Docket Nos. 50-280
and 50-281 ✓

bcc: H. Mueller, GMR/H
J. R. Buchanan, ORNL
T. W. Laughlin, DTIE
F. W. Karas, SECY
Change No. 4
License No. DPR-32

As a part of the operating license review conducted for Surry Power Station Units 1 and 2, a single set of Technical Specifications was developed and intended to be used as the Regulatory requirements for the licensed operation of both Unit 1 and Unit 2. These Technical Specifications were subsequently incorporated as Appendix A to Operating License No. DPR-32 for Surry Unit 1 issued on May 25, 1972 and are currently in effect for Unit 1.

UPPER PRESSURIZATION LIMITS
FOR HEATUP AND COOLDOWN
SURRY UNITS NO. 1 AND 2

TS Figure 3.1-1
1-17-73

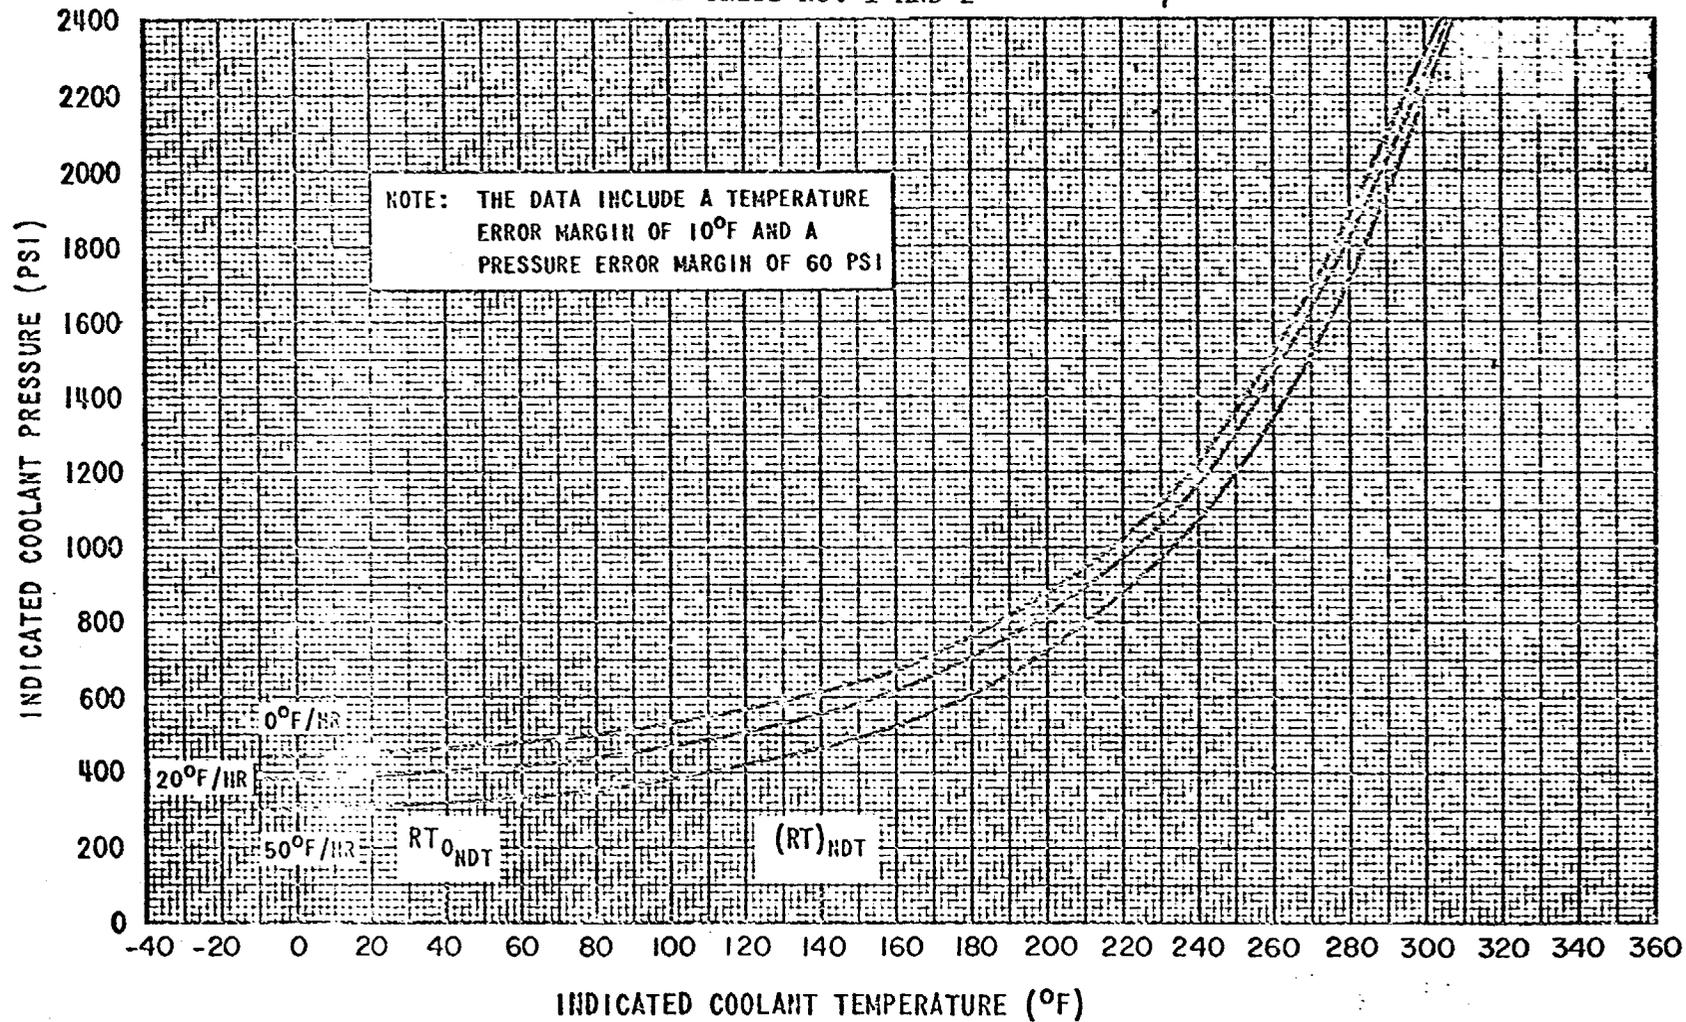
1. Change Technical Specification 3.1.B.1 page TS 3.1-6 (first paragraph) to read, "Unit 1 and Unit 2 reactor coolant temperature and pressure and the system heatup and cooldown (with the exception of the pressurizer) shall be limited in accordance with TS Figure 3.1-1".
2. Change Technical Specification Figure 3.1-1 entitled "Upper Pressurization Limits for Heatup and Cooldown - Surry Unit One" to read "Upper Pressurization Limits for Heatup and Cooldown - Surry Units No. 1 and 2".
3. Change Technical Specification 4.1 by redesignating Table 4.1-3, page TS 4.1-11, entitled "Minimum Frequencies for Flushing Sensitized Pipe" to Table 4.1-3A - Unit No. 1.

1. Unit 1 and Unit 2 reactor coolant temperature and pressure and the system heatup and cooldown (with the exception of the pressurizer) shall be limited in accordance with TS Figure 3.1-1. 4

Figure 3.1-1 Upper pressurization limit for heatup is depicted by "0°F/Hour" curve. Upper pressurization limits for cooldown are dependent as depicted, on the cooldown rates. This figure is applicable through an nvt of 1.1×10^{18} neutrons per cm^2 ($E > 1$ Mev)
